MEMORANDUM

To:	Wabasha City Council
Cc:	Caroline Gregerson Wabasha City Administrator
From:	David L. Betts, PE Project Manager
Date:	October 29, 2025
Re:	City of Wabasha TH 60 Realignment SP 079-080-001 & SP 7910-16 Project Concepts Review and Preferred Alternate Selection

CITY OF WABASHA
TRUNK HIGHWAY 60 REALIGNMENT
LAYOUT C2

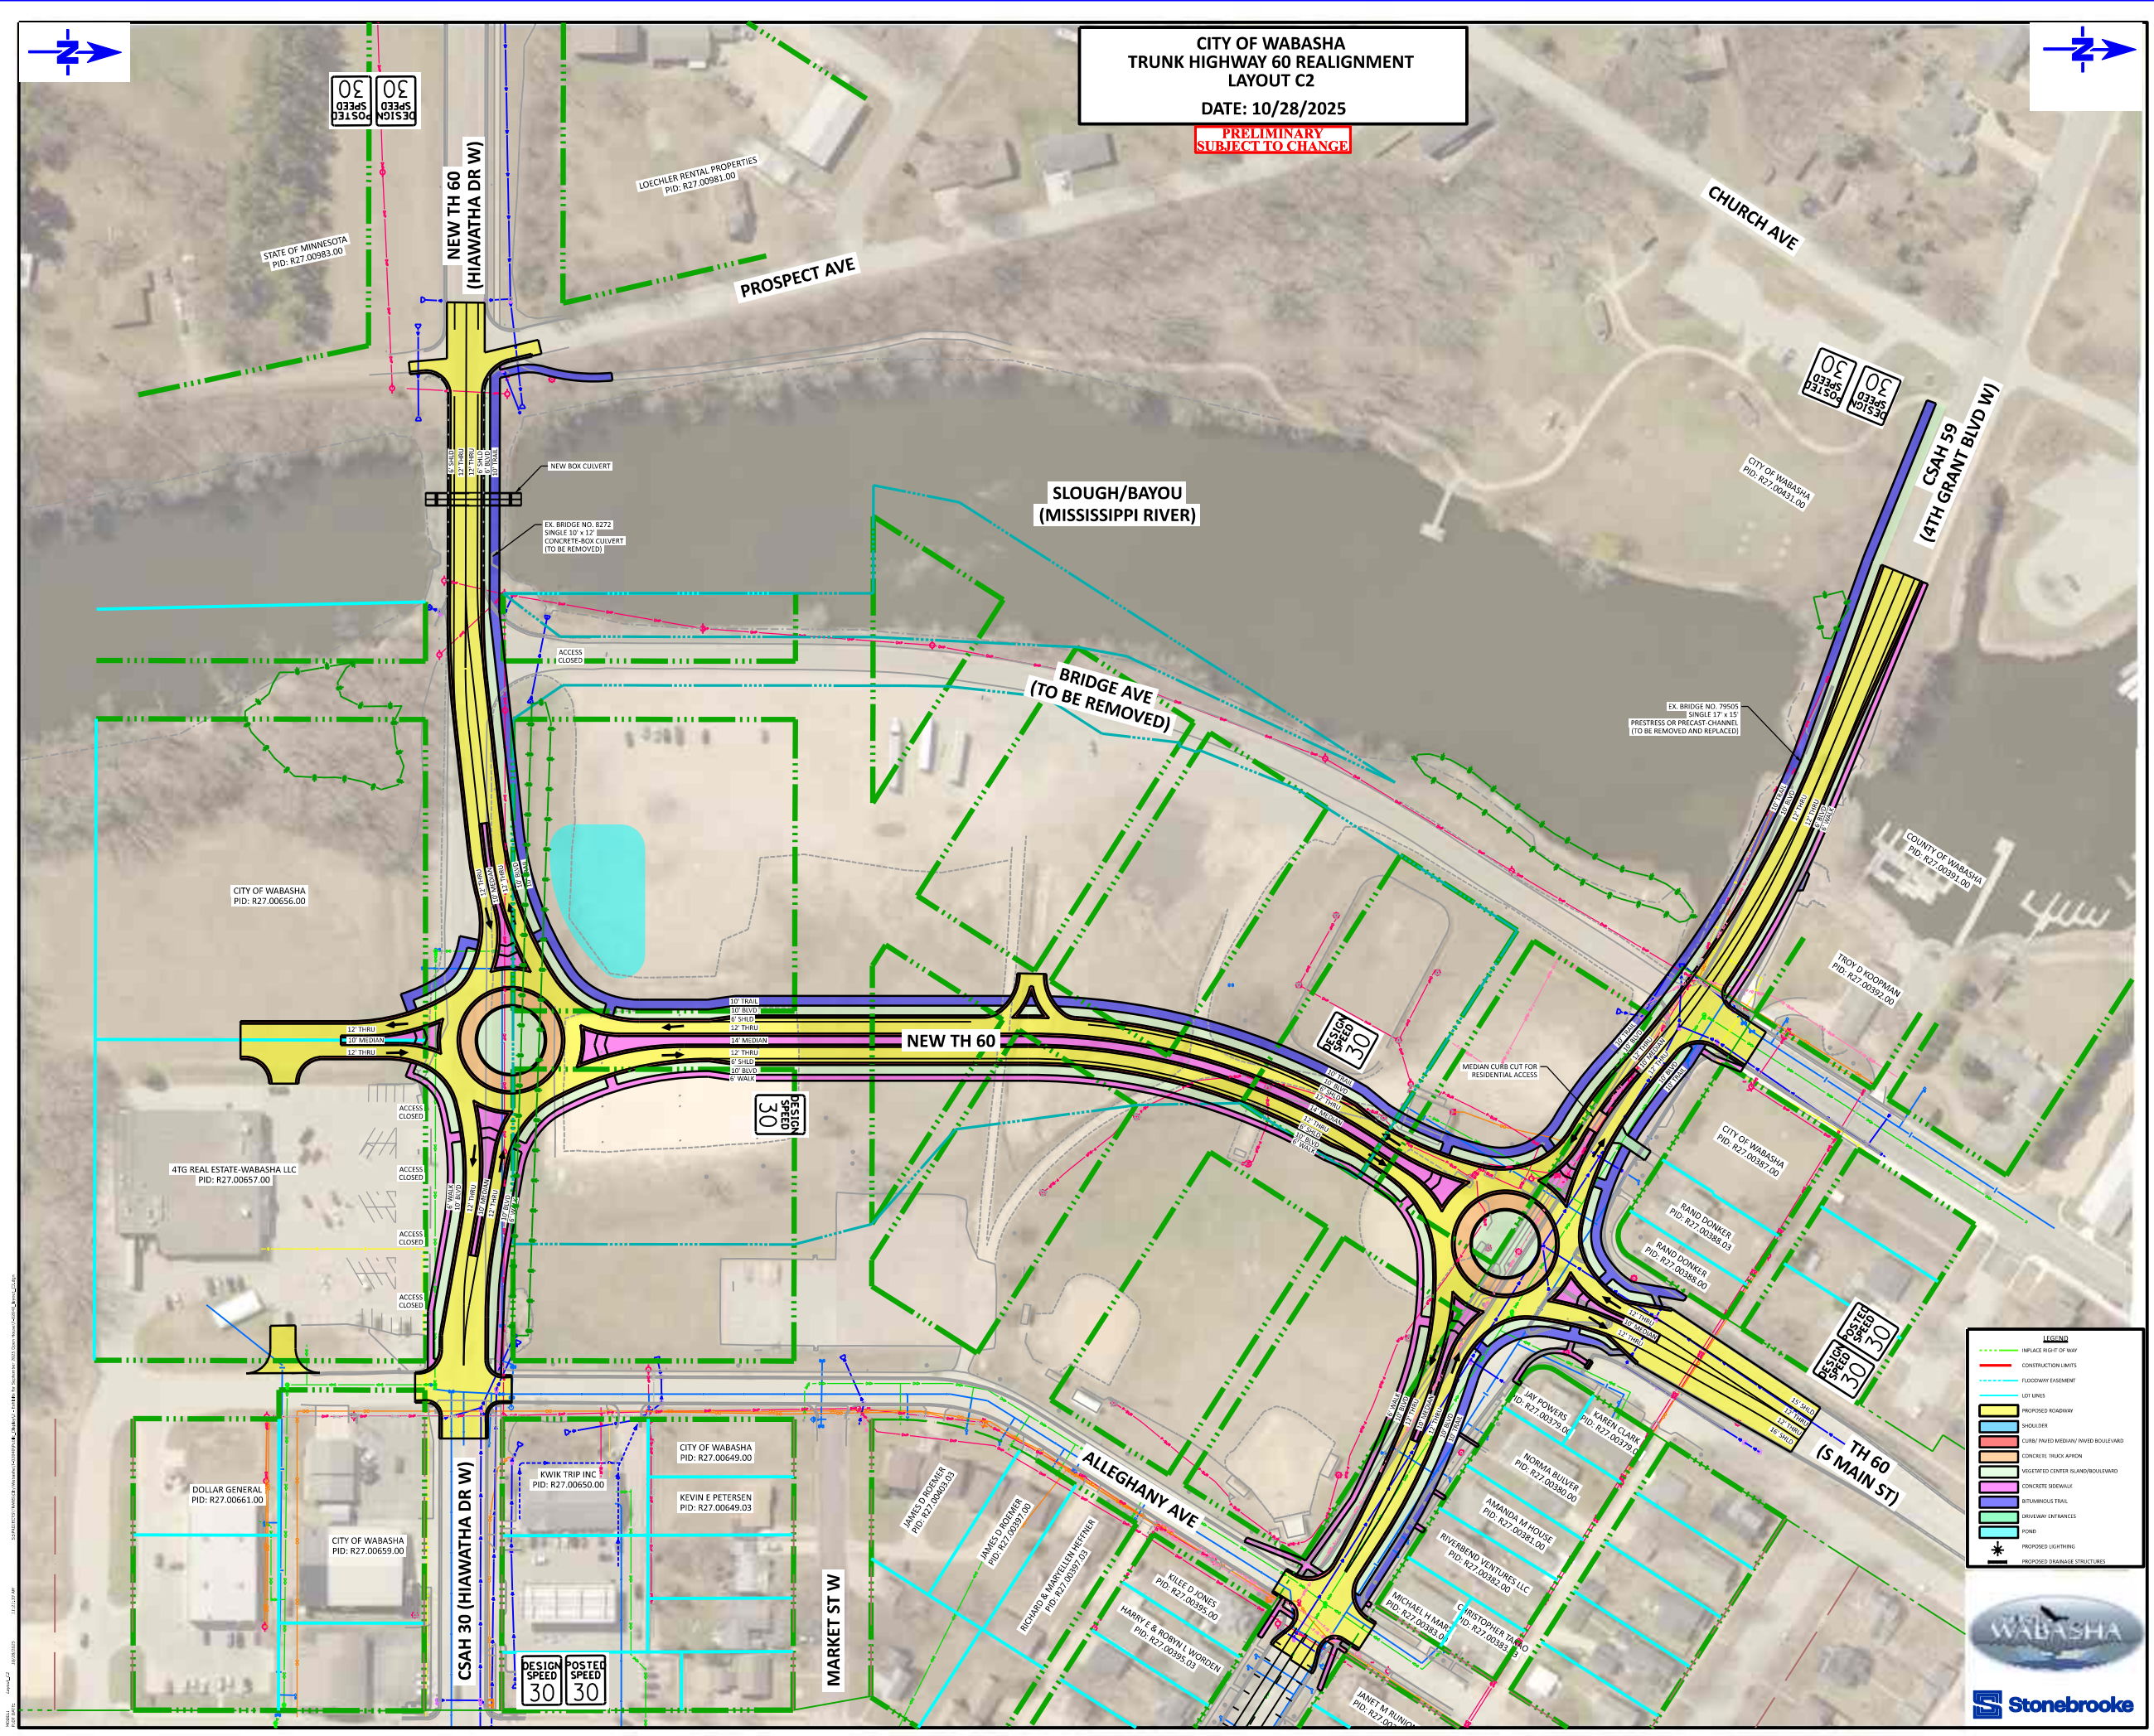
- In Layout C2, the project can't be constructed without permanent right-of-way acquisition from a commercial business (grocery store). Businesses often see parking as valuable property, and value access directly from a primary road, which currently has many; both of which may leave right-of-way acquisition problematic and costly. A suggestion would be to move the roundabout north, approximately 50'+ to avoid permanent right-of-way acquisition for the grocery. A suggestion would be to have at least one access from Hiawatha Dr to the grocery parking lot.

- On Layouts C1 and C2, there is also no shoulder shown on Hiawatha Dr that would transition to a bike ramp to a trail/sidewalk from either direction. Except in the roundabout and roundabout medians, a shoulder on Hiawatha and Grant is preferred by the County. Truck traffic (and especially with snowbanks) would seem to make a traffic-lanes-only road on this freight corridor(s) narrow.

- Parking for marina users may want to be considered by the City along Grant Blvd north of the bridge.
- Layout C2 shows a 10' trail and sidewalk, both with boulevards; the wider the width, the more cost (especially for the proposed box culvert replacement) and impact/fill to the water resource.

- It should also be noted that there would be more impacts to traffic during construction for the Hiawatha Dr traffic that could be reduced/minimized if the roundabout is shifted off the alignment of the existing roadway.
- While the C2 Hiawatha Dr roundabout does address and comply with MnDOT's previous comment that all legs of the roundabout are necessary to be a roadway and not a driveway, this does add a leg that would be required to be maintained by the City. Has there been consideration that the mosquito field area be utilized for storm water requirements, allowing for the area North of Hiawatha to be free of the storm water pond?

- I agree with Dietrich's comment about shifting the south roundabout to avoid the need for permanent property acquisition from the grocery store. That should be doable.
- I assume there has already been discussion about access to the property between Alleghany and the new TH 60? Is the intent for access to that property to come off Alleghany as opposed to providing a right-in/right-out access off TH 60, similar to the property west of TH 60? If there hasn't been a discussion already, you might want to consider requesting that right-in/right-out access be added on the east side of TH 60, similar to the west.
- Other than that, I think it looks great! The two roundabouts will be a huge safety improvement. I'm excited to see this move forward. It will be a really great improvement for the City that has been a long time coming.

- After speaking with the County, County Engineer Flesch intended to move the roundabout west, rather than north.
- If we moved the C2 roundabout 50 feet west, it would allow for a road to be constructed entirely on the City parcel (Mosquito Field). It would also allow for an entrance onto Hiwatha Drive to be maintained, if desired. It would require additional driveway length from the existing grocery store parking lot to the new south leg roadway.

- 1) Eliminate Layout A and Layout B from consideration due to intersection safety and operations issues.
- 2) Select Layout C2 as the preferred alternative, with any conditions or revisions.
- 3) Motion to incorporate suggestions by County, City engineering staff, and City Planner into the final designs and project as permitted.
